BROADWATER ROAD

report **Broodwater Road, Welwyn Garden City**
568
Urban Design Response to Committee Report

6 January 2012

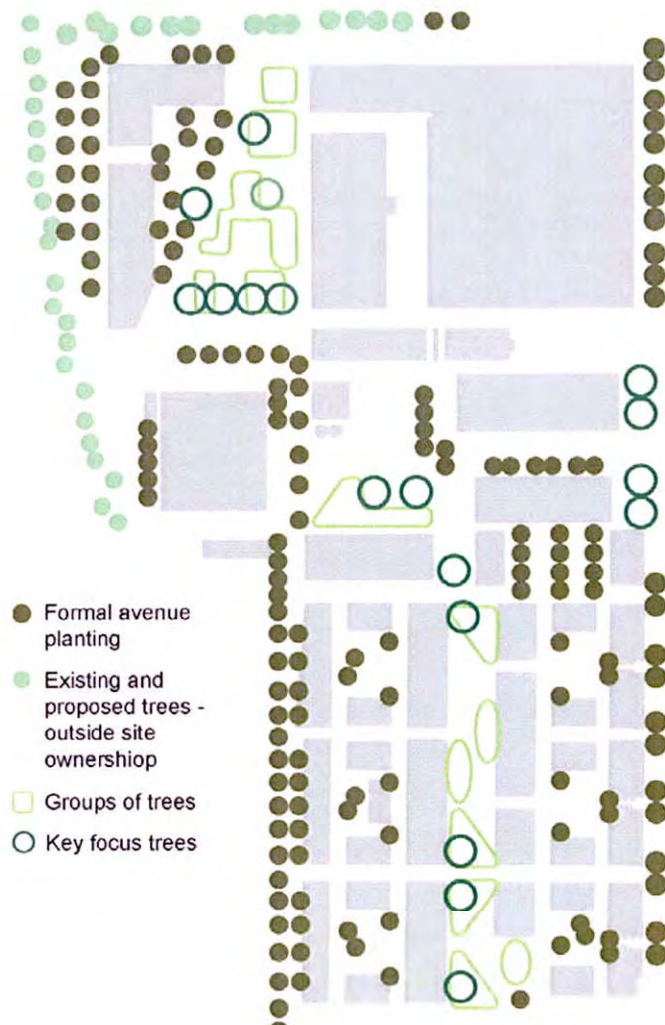
8.199However existing trees are not capitalised upon in the application proposals the loss of mature tree, without adequate replacement is not acceptable.

Our schemes retain more than 30 trees and the proposal is to plant more than 330 trees, although there is a loss of 67 existing trees. This represents more than adequate replacement of trees across the site. The large majority of the losses are the result of the requirements placed on the scheme to improve highway capacity in the area.

A further group of trees has been removed along the north-south boulevard in order to ensure that the new trees which are established form a consistent formal avenue in keeping with garden city landscape form rather than relying on the existing planting which varies considerably in size, position and quality. Only one group of trees is removed to facilitate the delivery of new buildings - the new leisure centre building.

A detailed explanation of the planting strategy and the garden city principles was included in the report submitted to WHBC in September 2011.

The diagram above indicates the four typologies of garden city planting incorporated in the Broadwater West proposals namely:

- Principle avenue trees
- Key focus trees
- Tree groups
- Supportive tree planting

BROADWATER ROAD WEST, WELWYN GARDEN CITY
 OUTLINE PROPOSAL
 PARAMETER PLAN - PEDESTRIAN AND CYCLE ROUTES
 588_PP_07_008
 SCALE: 1:500 @A4 11000 8242

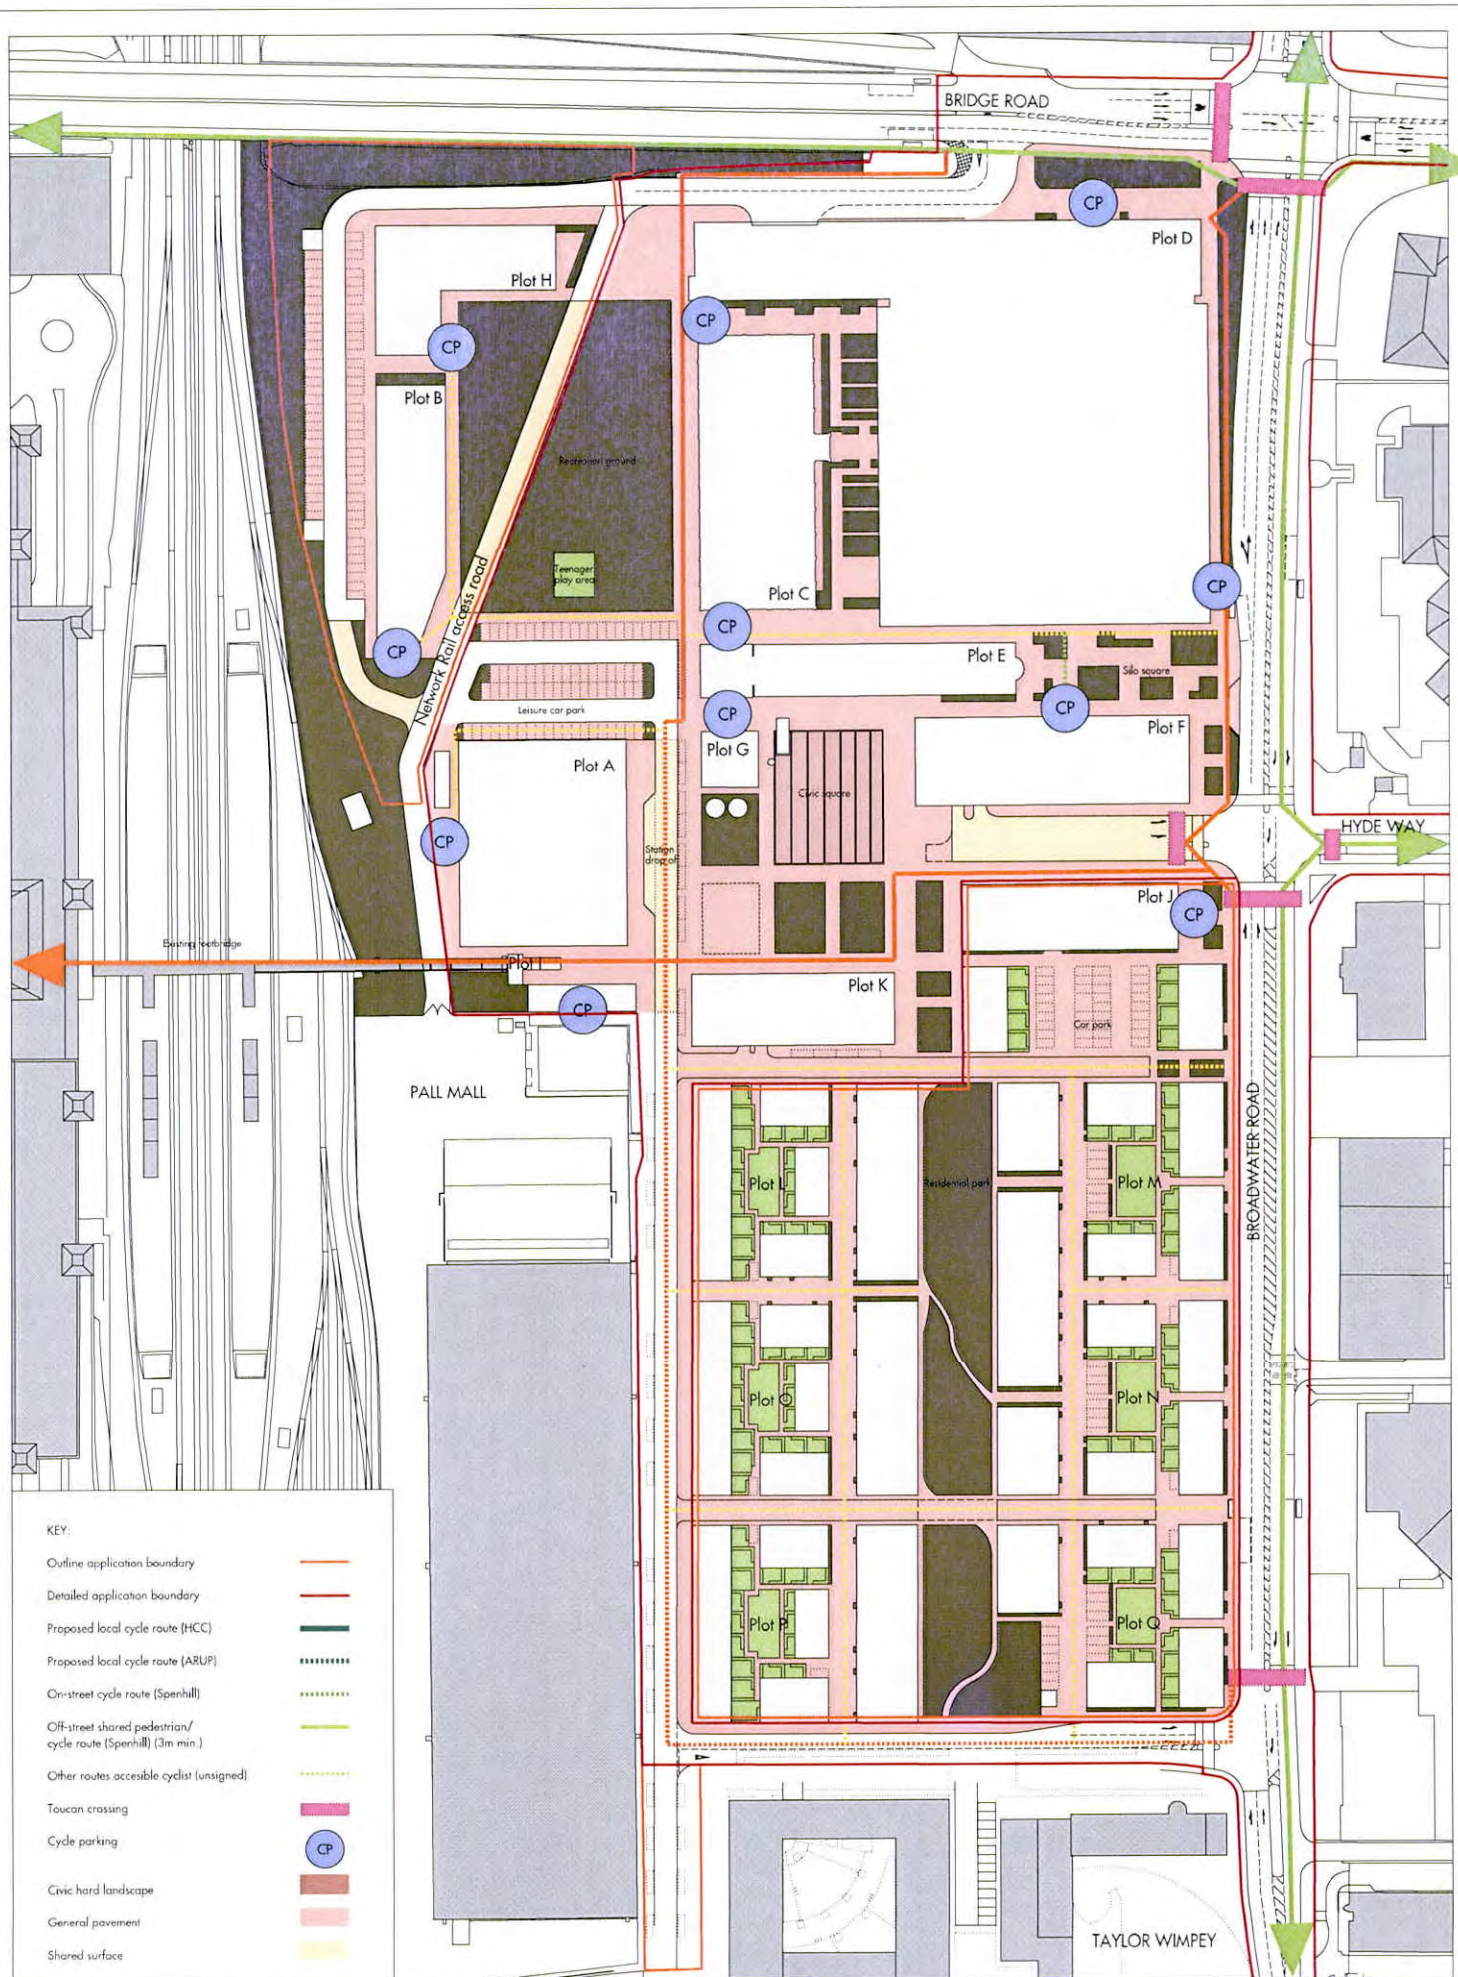
The cycle route to the south of the civic square, which is not safe for pedestrians and relies on the outline proposals for delivery.

The Parameter Plan "Pedestrian and Cycle Access" (568_PP_07_008), attached, was revised in September 2011 to address minor issues raised by Tibbalds UDA.

The cycle route provided that connects the railway bridge to Hyde Way is delivered within the detailed application boundary.

The revised parameter plan "Pedestrian and Cycle Access" (568_PP_07_008) was issued to WHBC in September 2011, attached, and clarified minor issues raised within Tibbalds UDA.

The route of the shared east-west cycleway and footway between Broadwater Road and the railway footbridge was amended following comments from Hertfordshire Highways in June 2011. The route now passes along the south of Hyde Way to the north of Building J, as illustrated on the revised parameter plan (INSERT FIG) and in figure 5.3: Cycle access and circulation on page 32 of the Transport Assessment report.

BROADWATER ROAD WEST, WEALYN GARDEN CITY
 OUTLINE PROPOSAL
 PARAMETER PLAN - GROUND FLOOR USES + FRONTAGES
 568_PP_07_012
 SCALE: 1:500 (SHEET 1 OF 2)

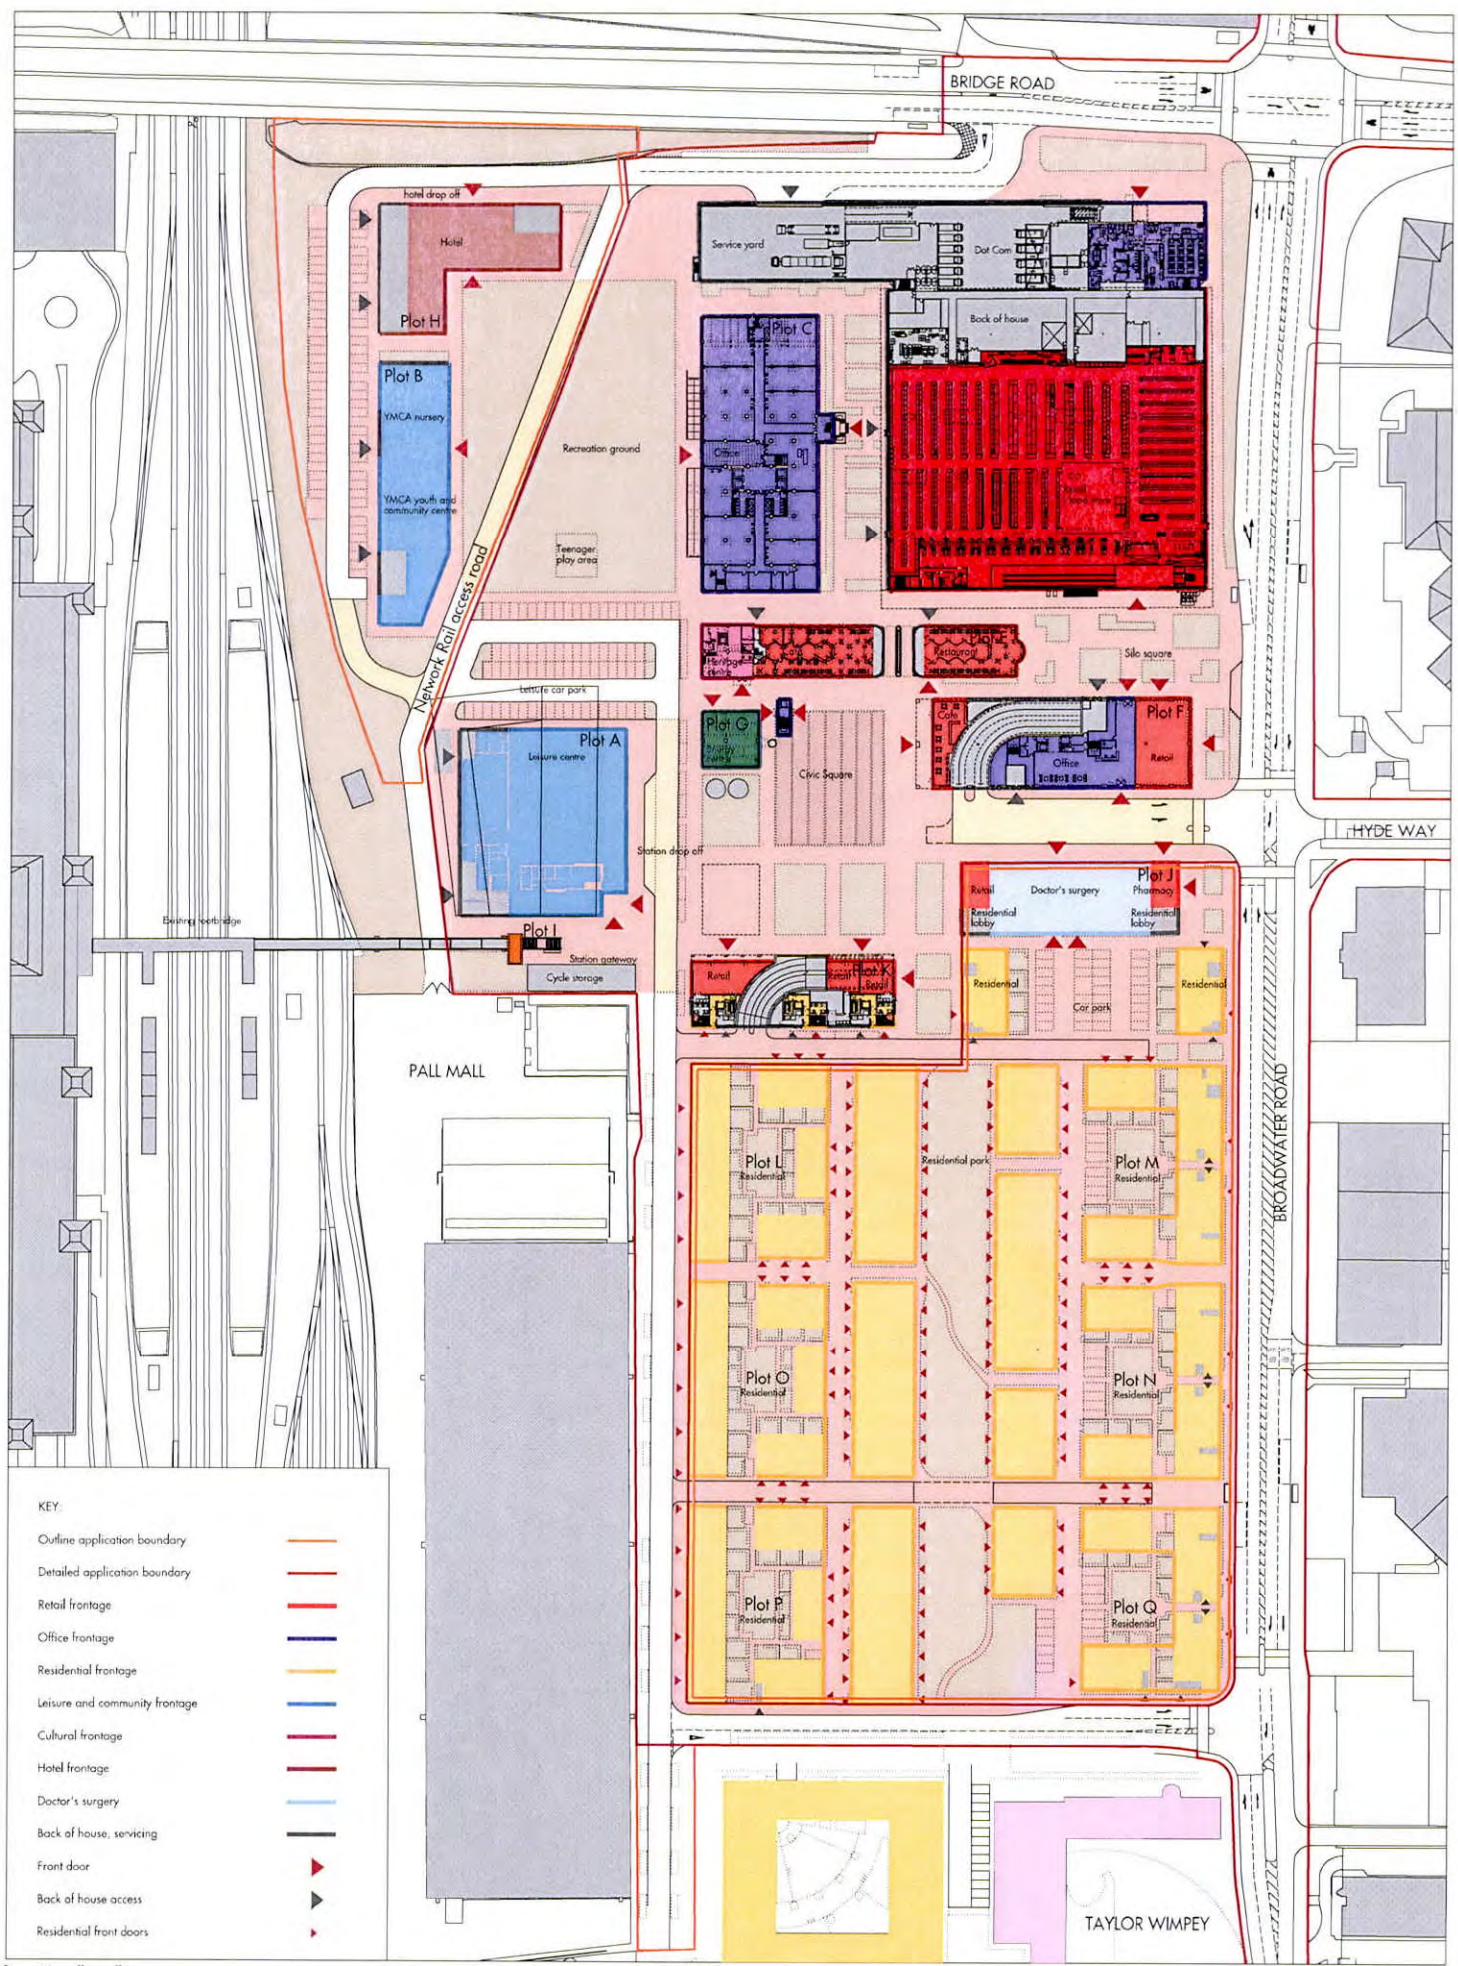
- southern edge of the supermarket, its entrance, access and circulation arrangements

Updates to the Parameter Plan "Ground floor uses and frontages" (568_PP_07_012), as attached revision, were proposed in September 2011 to address minor issues raised by Tibbalds UDA.

BROADWATER ROAD WEST, WELWYN GARDEN CITY
 OUTLINE PROPOSAL
 PARAMETER PLAN - PRIMARY/SECONDARY ACTIVE FRONTAGES
 568_PP_07_018
 SCALE: 1:500 (A4) 1:1000 (A3)

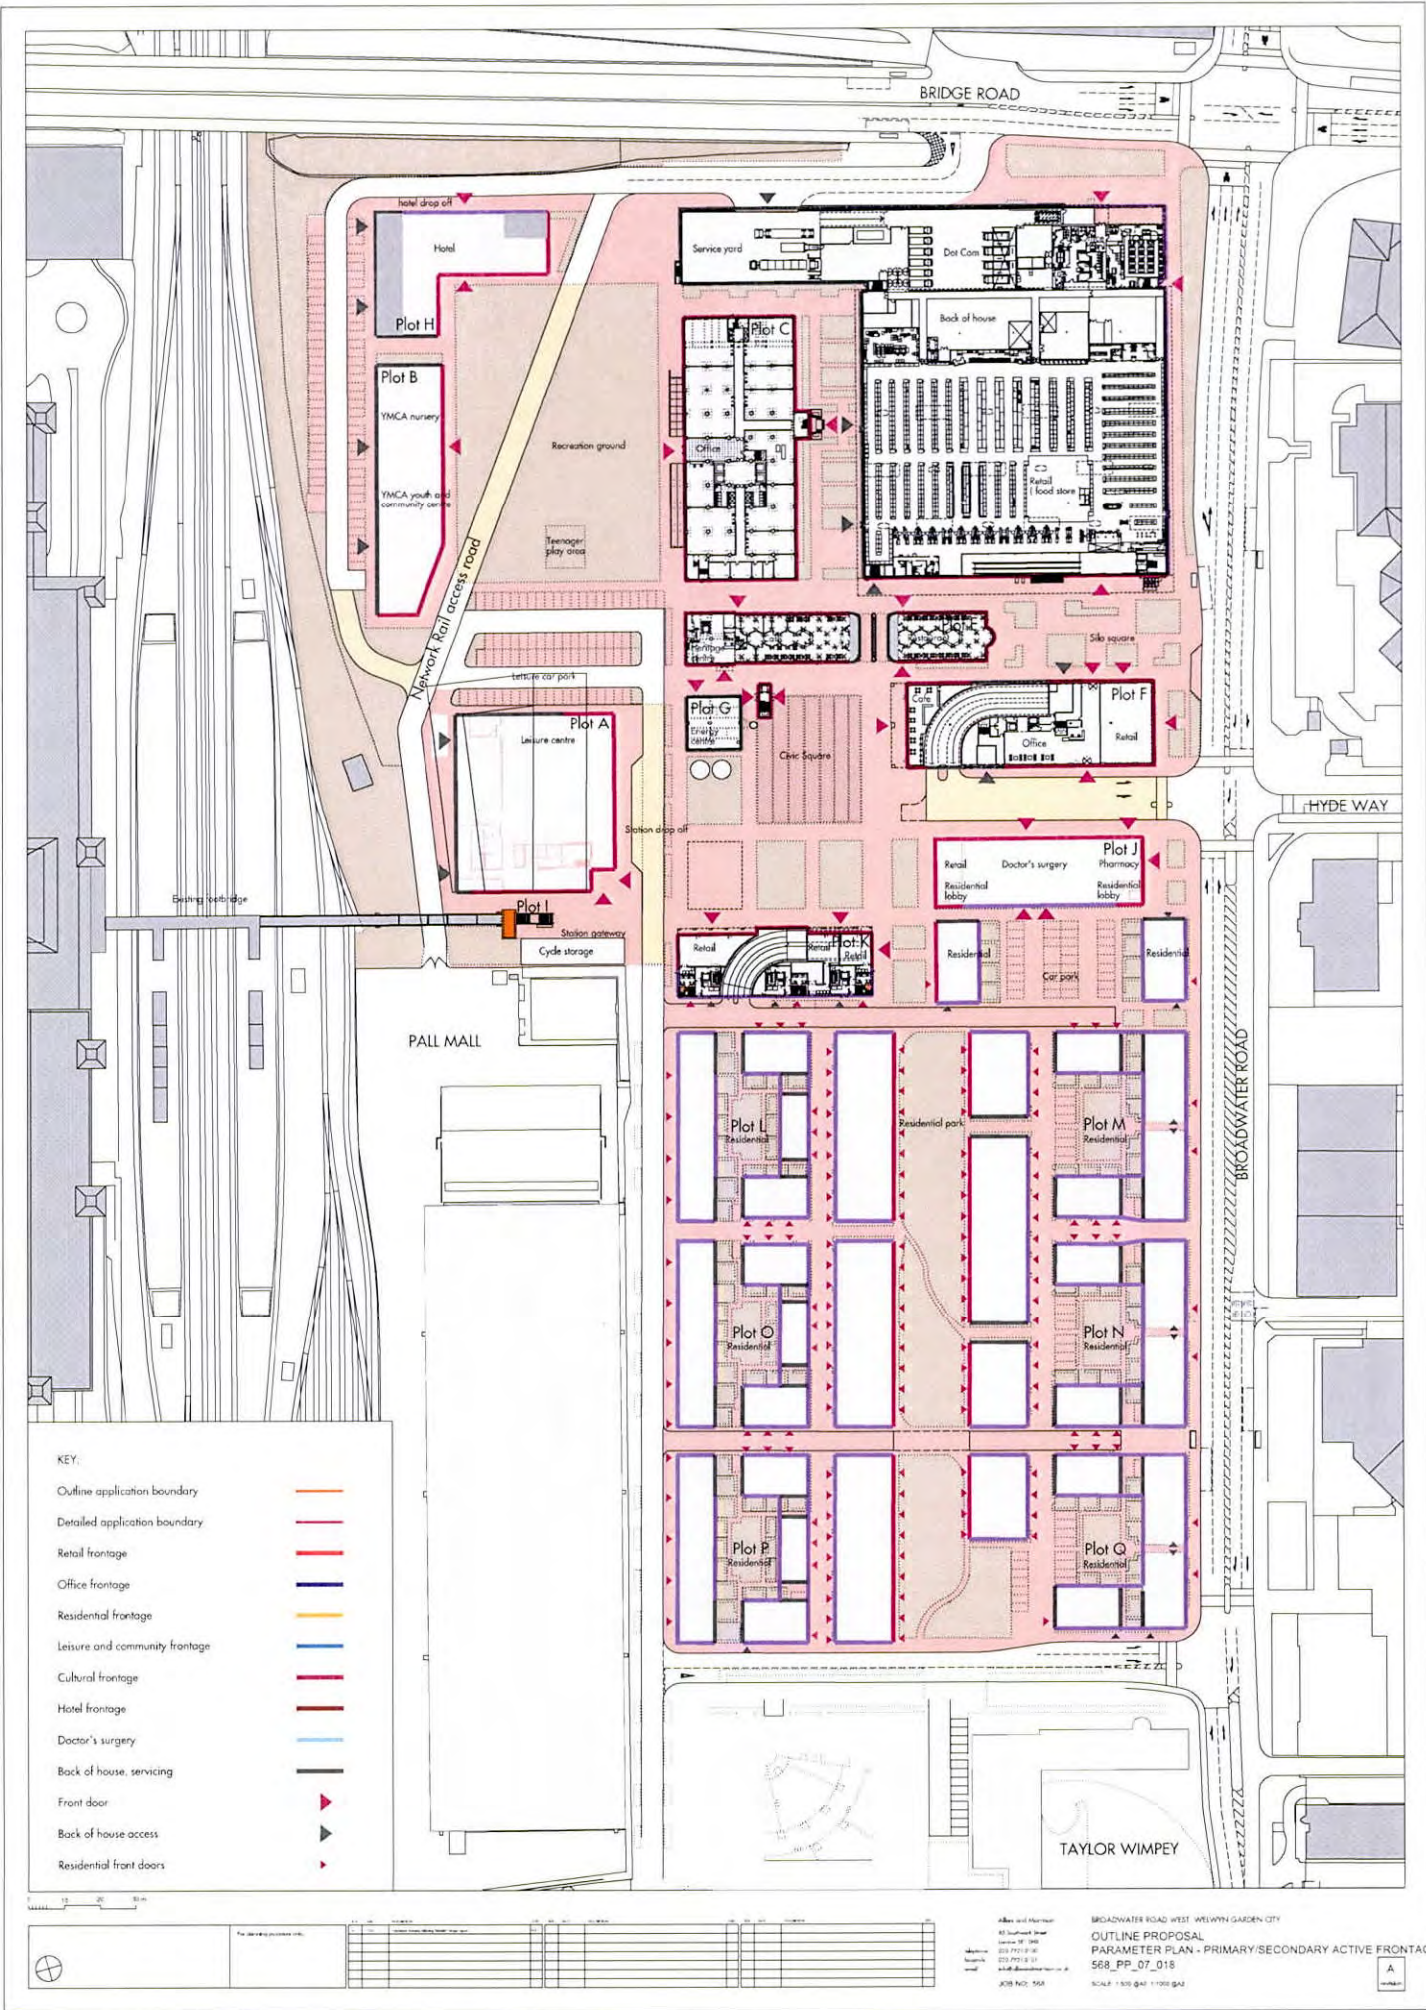
The dead frontage of the supermarket on Broadwater Road which does not promote safety

The Parameter Plan "Primary and Secondary Active Frontages" (568_PP_07_018), attached, was prepared in September 2011 to address minor issues raised by Tibbalds UDA.

The Parameter Plan "Primary and Secondary Active Frontages" (568_PP_07_018), attached, was prepared in September 2011 to address minor issues raised by Tibbalds UDA.
